In October 2015, the *Greater Cambridge City Deal Executive Board* launched a formal public consultation, asking the public for its views on the best route for *a new bus & cycle-route between Cambourne and Cambridge*.

██████████ is a response to that consultation.

Madingley Road / A428 Cambourne to Cambridge Corridor Study  
Interim Report

## New Park & Ride on the A428 at the Scotland Road roundabout

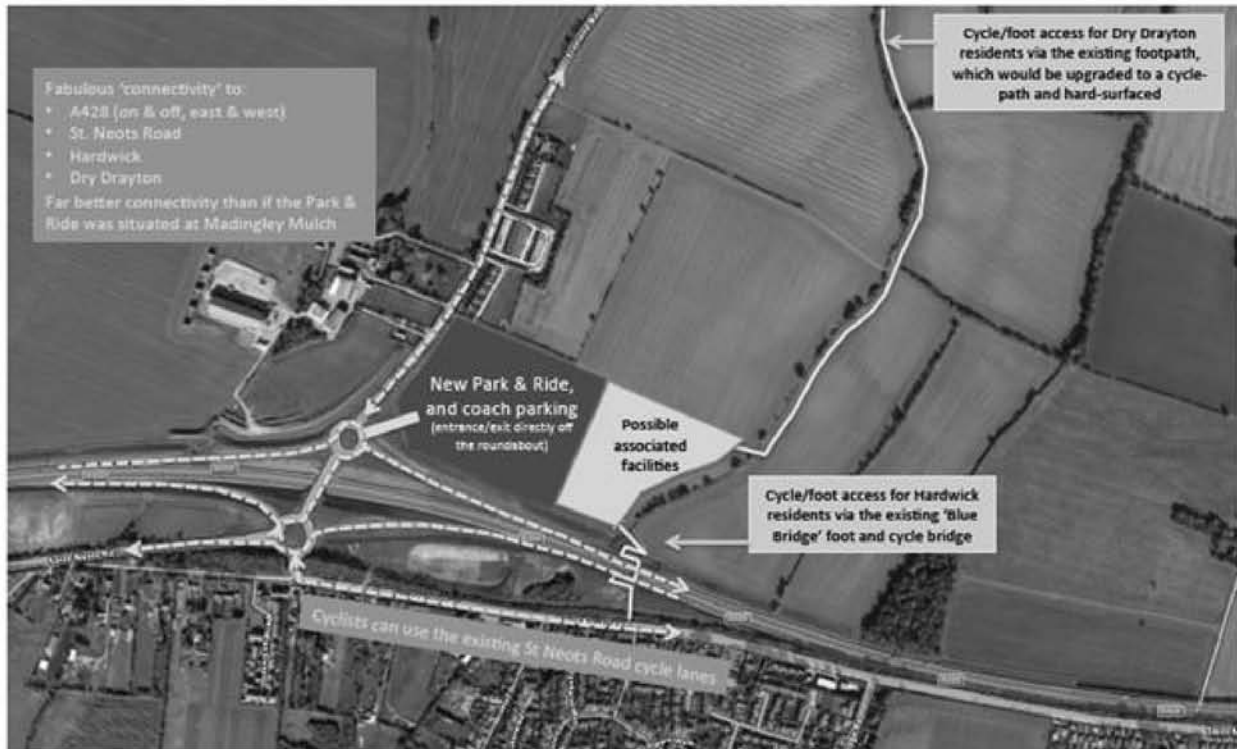
Fabulous 'connectivity' to:

- A428 (on & off, east & west)
- St. Neots Road
- Hardwick
- Dry Drayton

Far better connectivity than if the Park & Ride was situated at Madingley Mulch

## Madingley Mulch roundabout is the wrong place for a new Park & Ride

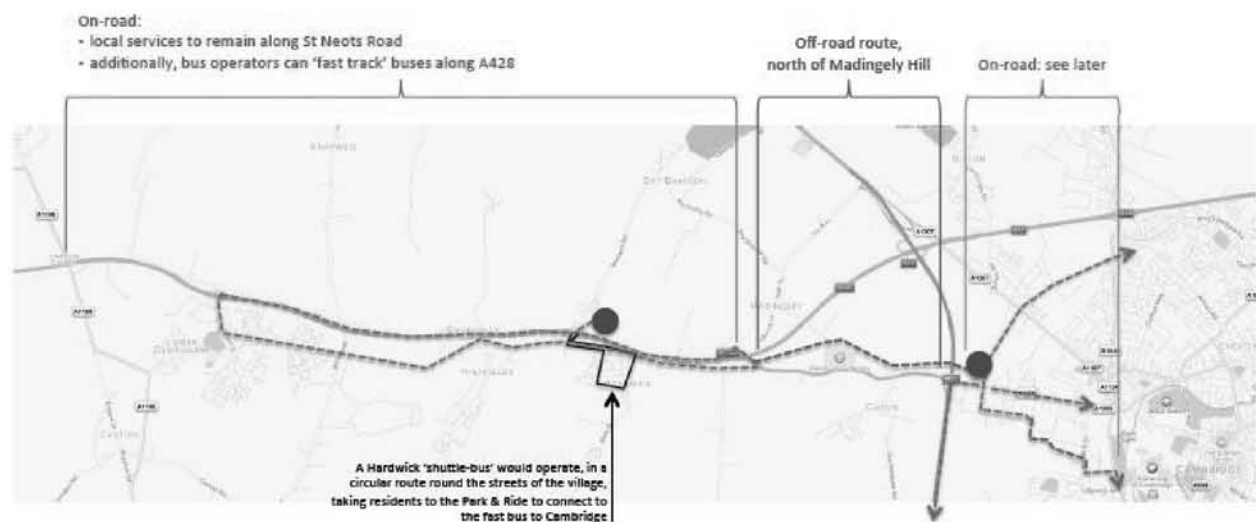
- The City Deal Board's public consultation suggested that a possible location for the new Park & Ride could be by the Madingley Mulch roundabout
- **We disagree**, because:

- the roundabout is very busy, with a difficult layout
  - it is too close to Madingley Hill, a traffic congestion hot-spot we are all trying to avoid

- there would be too much harmful impact on the nearby villages of Madingley and Coton
- **The City Deal public consultation (question 15) asks for recommendations for other locations**

## Off-road route : City Deal "Area 1 North"

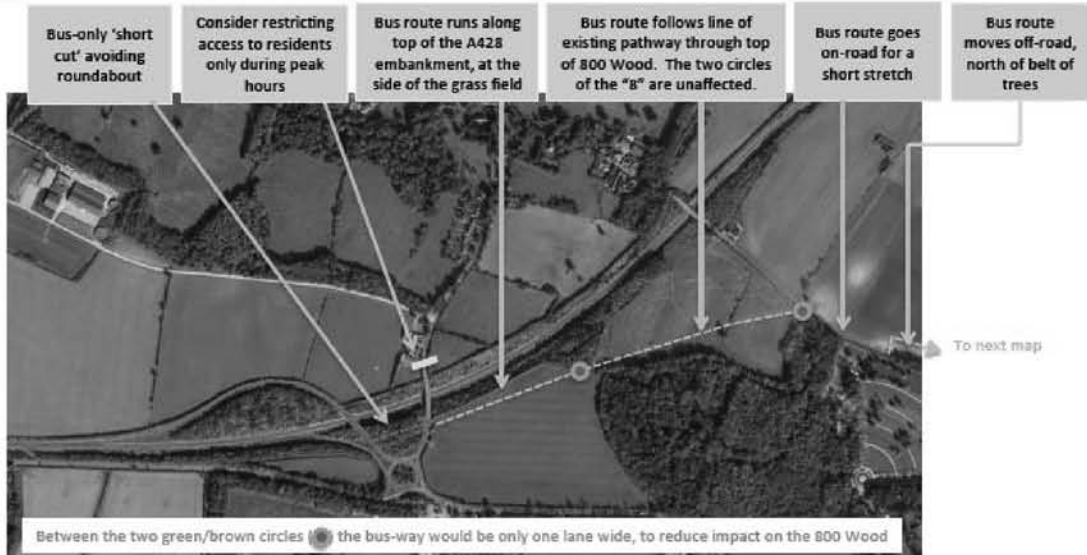
In proposing "Area 1 North", we note that:

- many commentators have recommended Area 1 Central, i.e. a bus lane(s) down Madingley Hill. We fear that will not provide as fast, or as reliable, a bus service as an off-road route and, as our mission has always included to be "bold", we prefer a more comprehensive and future-proof solution

- there has been an extreme public reaction against Area 1 South, but significantly less public comment against Area 1 North
- Cambridge Past Present & Future, whilst favouring Area 1 Central, has recommended Area 1 North as its fall-back option, rather than Area 1 South

## M11 Junction 11

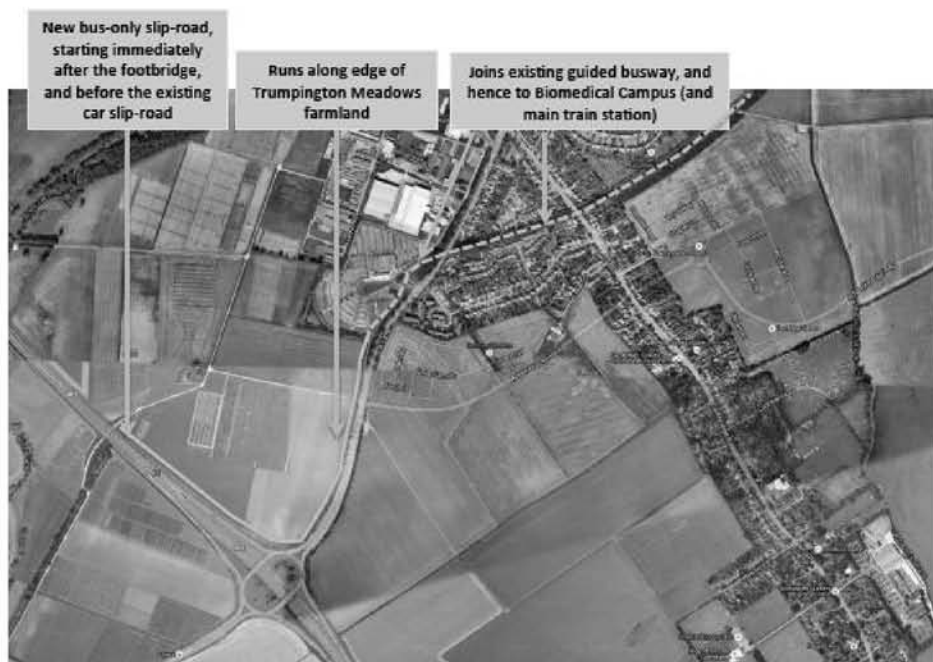
- At Junction 11, a new bus-only slip-road would enable buses to go direct to the Guided Busway, by-passing the traffic lights (a) at the top of the existing slip-road and (b) at the turning onto the Addenbrooke's access road.
- Investigation of a new bus-only slip-road at M11 Junction 11 was supported by the Greater Cambridge City Deal Board on 1<sup>st</sup> October 2015
- This will enable buses to go direct from the M11 to the Guided Busway (and thence to the Biomedical Campus) without being held up at the existing junctions

## From Cambourne/Bourn Airfield, along Port Way/Whitwell Way

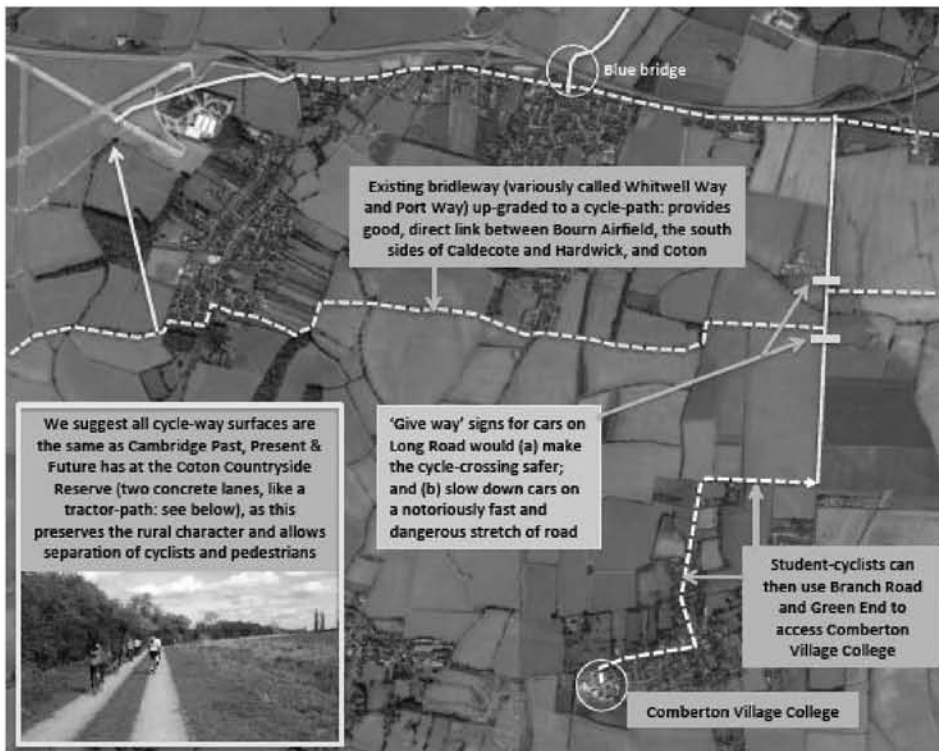
- We propose that the existing brideway (variously called Whitwell Way and Port Way) is up-graded to a cycle-path with a suitable hard surface.
- This will enable a direct cycle link between Cambourne/Bourn Airfield, via the southern edge of Caldecote and Hardwick Villages, to Coton and (as we shall see overleaf) the historic centre of Cambridge.
- Using B roads and village roads, cyclists would be able to continue on to:
  - o Caldecote Village
  - o Hardwick Village and then the blue bridge, thereby accessing the new Park & Ride
  - o Comberton and, in particular, Comberton Village College
  - o West Cambridge and North West Cambridge

1/

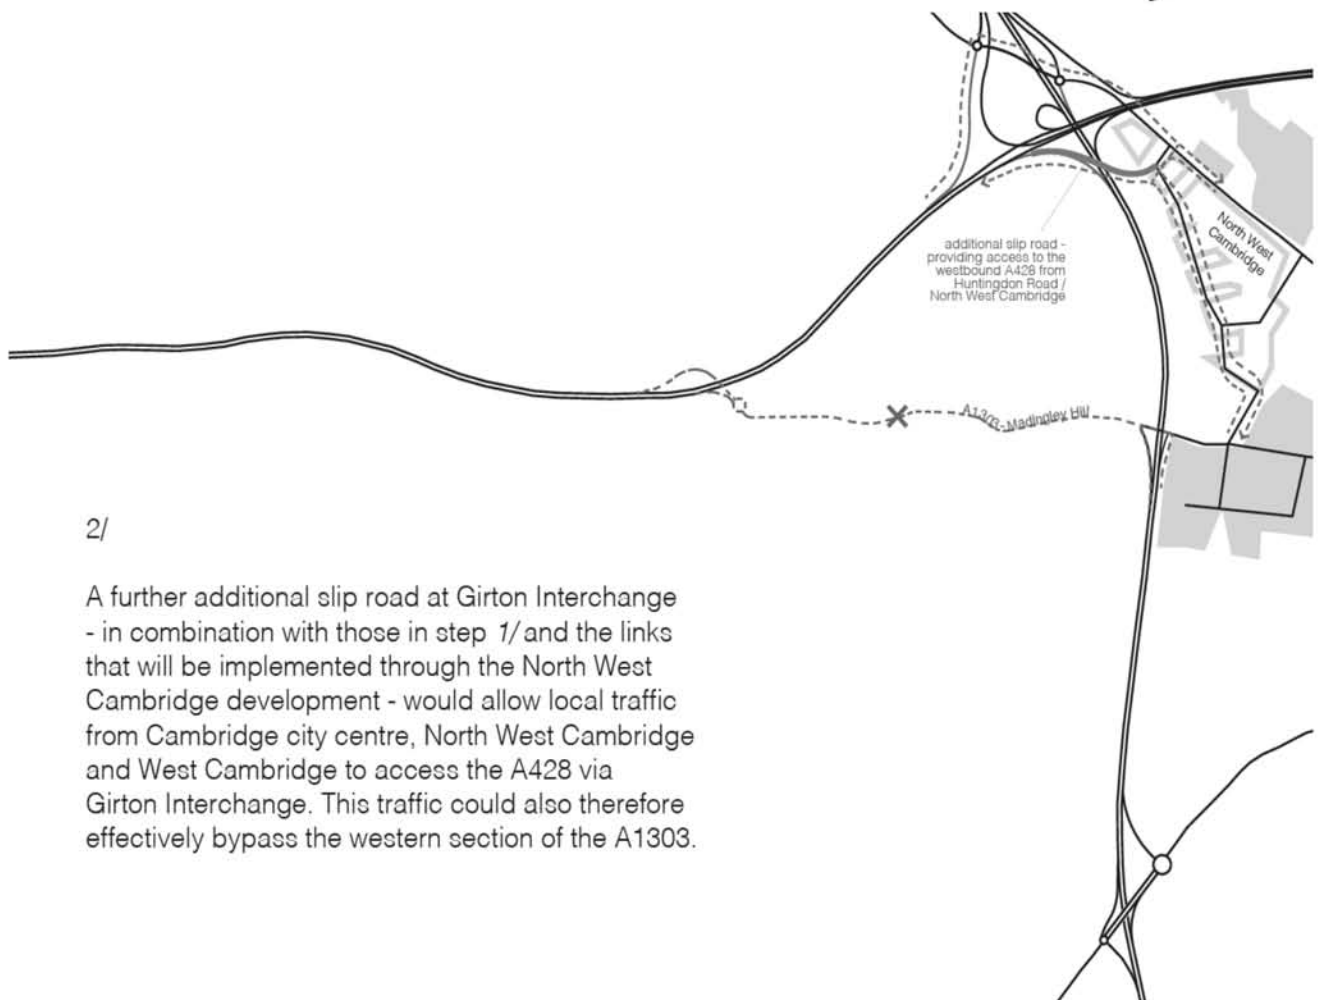
Three additional slip-roads at the rebuilt Girton Interchange - as already anticipated in Highways England's design for the junction\* - would allow long-distance traffic to be routed away from Madingley Hill / J13 of the M11.

2/

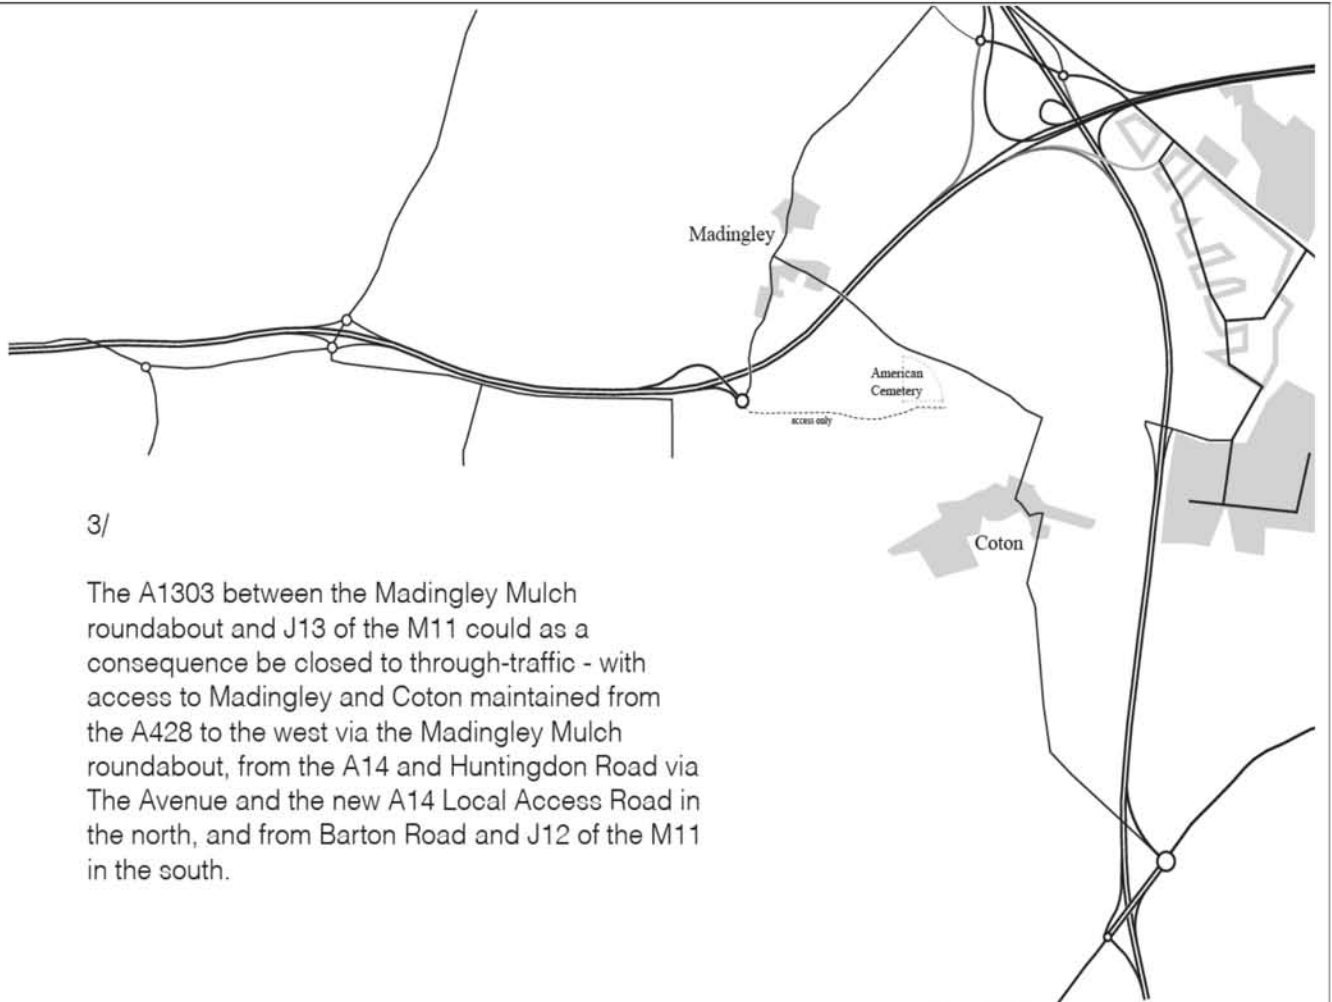
A further additional slip road at Girton Interchange - in combination with those in step 1/ and the links that will be implemented through the North West Cambridge development - would allow local traffic from Cambridge city centre, North West Cambridge and West Cambridge to access the A428 via Girton Interchange. This traffic could also therefore effectively bypass the western section of the A1303.

3/

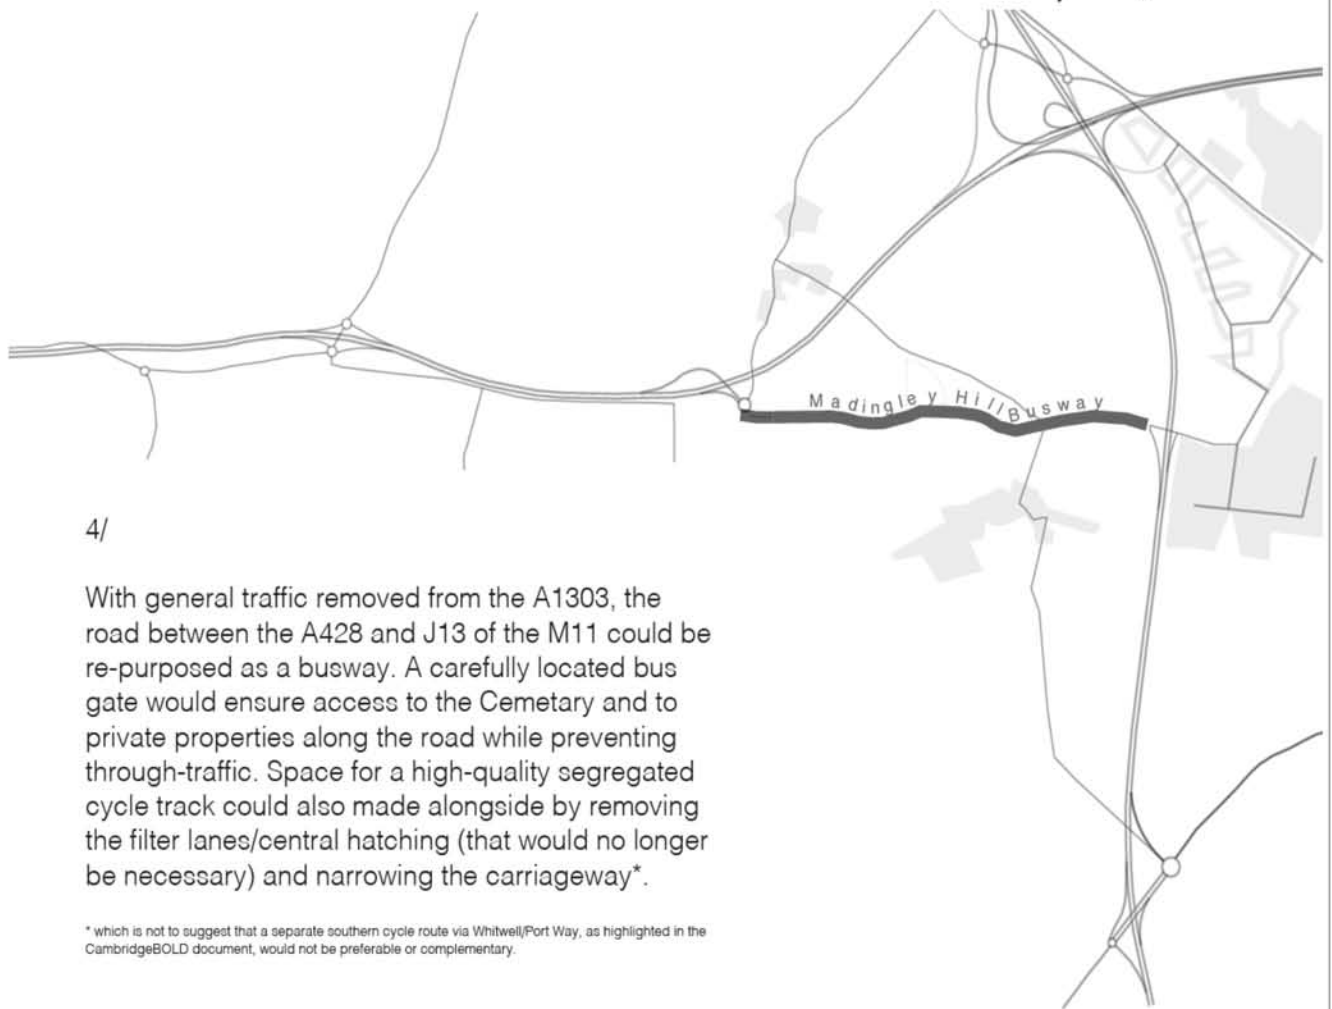
The A1303 between the Madingley Mulch roundabout and J13 of the M11 could as a consequence be closed to through-traffic - with access to Madingley and Coton maintained from the A428 to the west via the Madingley Mulch roundabout, from the A14 and Huntingdon Road via The Avenue and the new A14 Local Access Road in the north, and from Barton Road and J12 of the M11 in the south.

4/

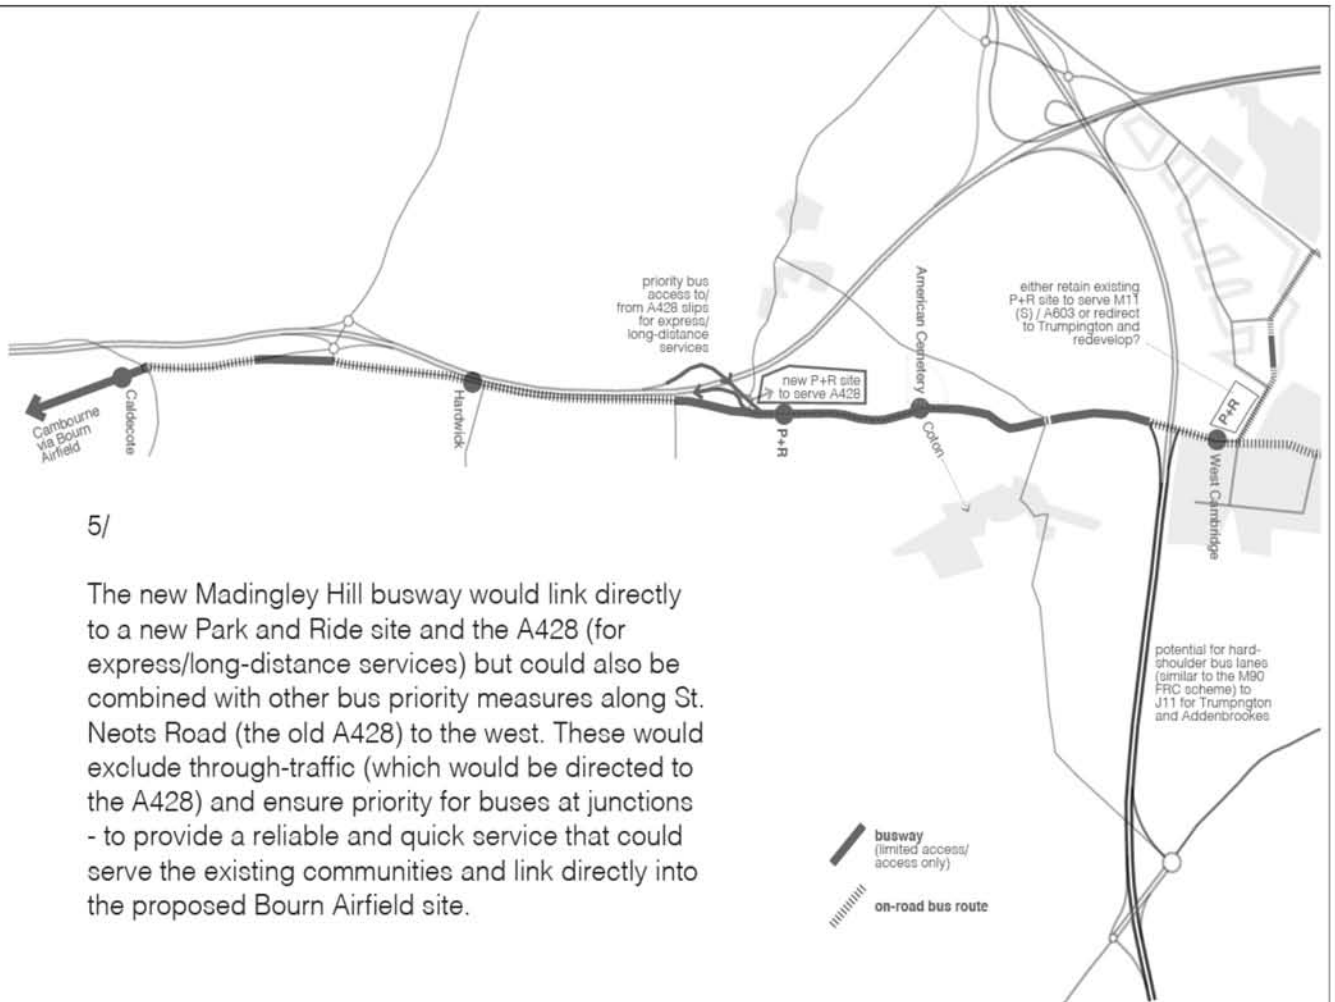
With general traffic removed from the A1303, the road between the A428 and J13 of the M11 could be re-purposed as a busway. A carefully located bus gate would ensure access to the Cemetery and to private properties along the road while preventing through-traffic. Space for a high-quality segregated cycle track could also be made alongside by removing the filter lanes/central hatching (that would no longer be necessary) and narrowing the carriageway\*.

Figure A-3 Option 1C

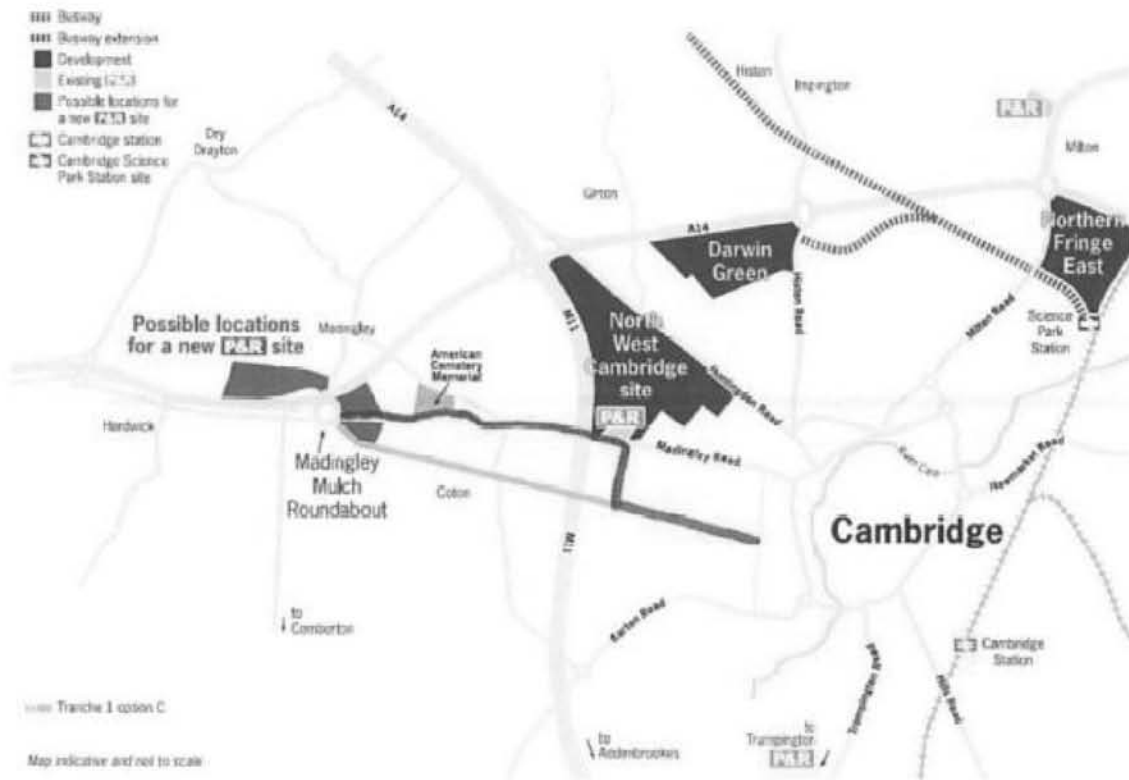
This line shows an alternative option where on-line improvements are made from Madingley Mulch roundabout to West Cambridge and then a new route through the West Cambridge site and then a fully segregated link leading to Grange Road.
